IEEE P802.15
Wireless Personal Area Networks

Project	IEEE P802.15 Working Group for Wireless Personal Area Networks (WPANs)	
Title	TG3 Rolling Meadows Ad-Hoc Working Document	
Date Submitted	[1 December, 2001]	
Source	[James P. K. Gilb] [Mobilian] [12707 High Bluff Dr., Suite 335, San Diego, CA 92130]	Voice: [858-436-2201] Fax: [858-436-2301] E-mail: [gilb@ieee.org]
Re:	[]	
Abstract	[This document is contains the issues and resolutions developed by the TG3 subcommittee at the Rolling Meadows ad-hoc meeting. It also serves to document the addtions made to the draft standard D07 to produce D08.]	
Purpose	[To provide a record of the resolutions of TG3 and the changes to the draft standard D07 to make D08.]	
Notice	This document has been prepared to assist the IEEE P802.15. It is offered as a basis for discussion and is not binding on the contributing individual(s) or organization(s). The material in this document is subject to change in form and content after further study. The contributor(s) reserve(s) the right to add, amend or withdraw material contained herein.

Figure 3—CTA assignment sequence for pseudo-static GTSs

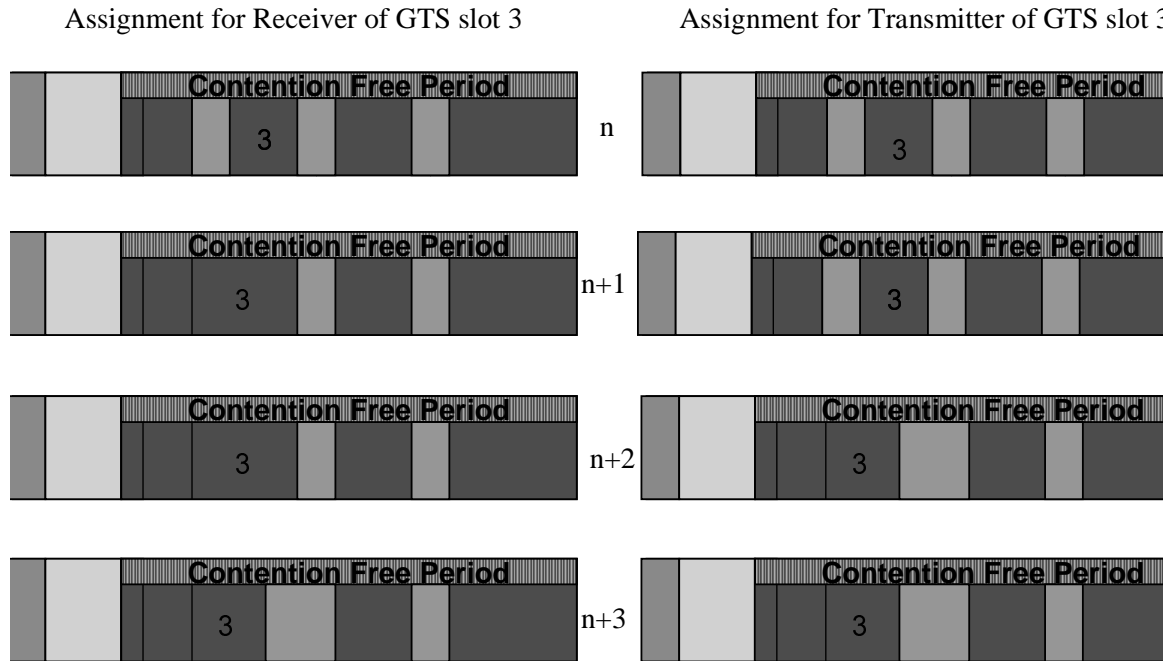
DEVs may request a change in a pseudo-static GTS channel time using the channel time request command. 13

A graphical illustration of the procedure for moving a pseudo-static GTS is illustrated in Figure 3

Ed action: The text added is given below: 4

Figure RR - Parent piconet and child piconet superframe relationship.

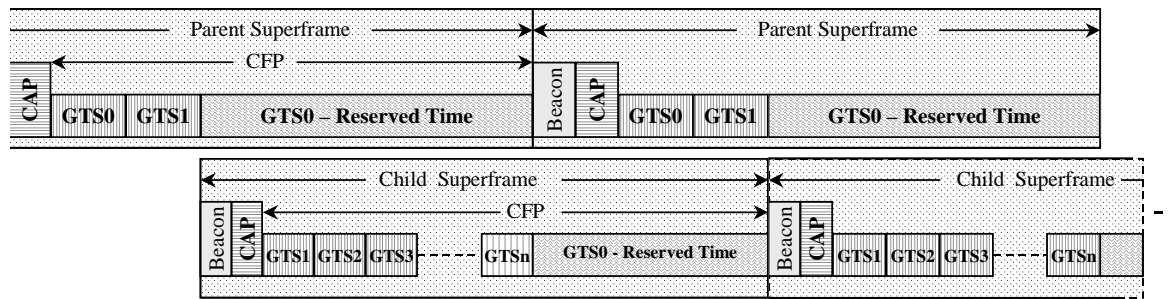
Figure RR illustrates the relationship between the parent piconet superframe and the child piconet superframe. It can be seen that the superframe duration is the same for both the child and the parent piconets.

Note: The slot positions GTS0, GTS1, et al, are illustrative.

Figure 66 illustrates the relationship between the parent piconet superframe and the child piconet superframe. It can be seen that the superframe duration is the same for both the child and the parent piconets.

Note that the slot positions GTS0, GTS1, et al, are not to scale in Figure 60 are illustrative only.

Figure abc – Message Sequence Chart: initiation of a child piconet

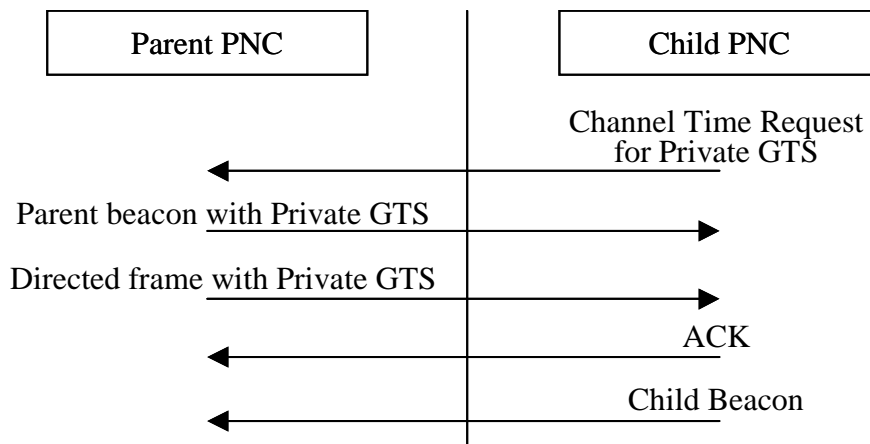
The message sequence chart for the initiation of the child piconet is shown in figure abc.

The message sequence chart for the initiation of the child piconet is shown in Figure 67.

Figure def – Message Sequence Chart: initiation of a neighbor piconet

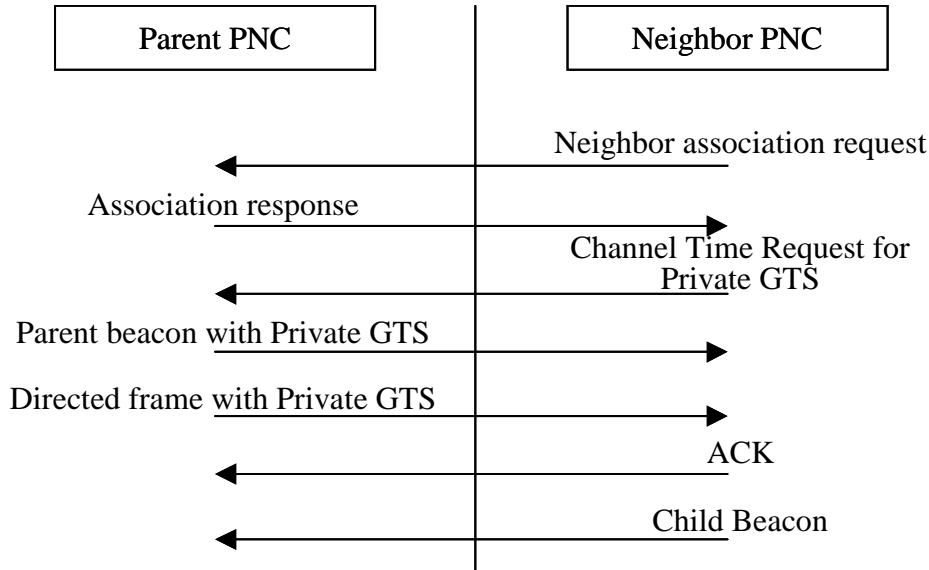
The message sequence chart for the initiation of the neighbor piconet is shown in figure def.

The message sequence chart for the initiation of the neighbor piconet is shown in figure Figure 68.
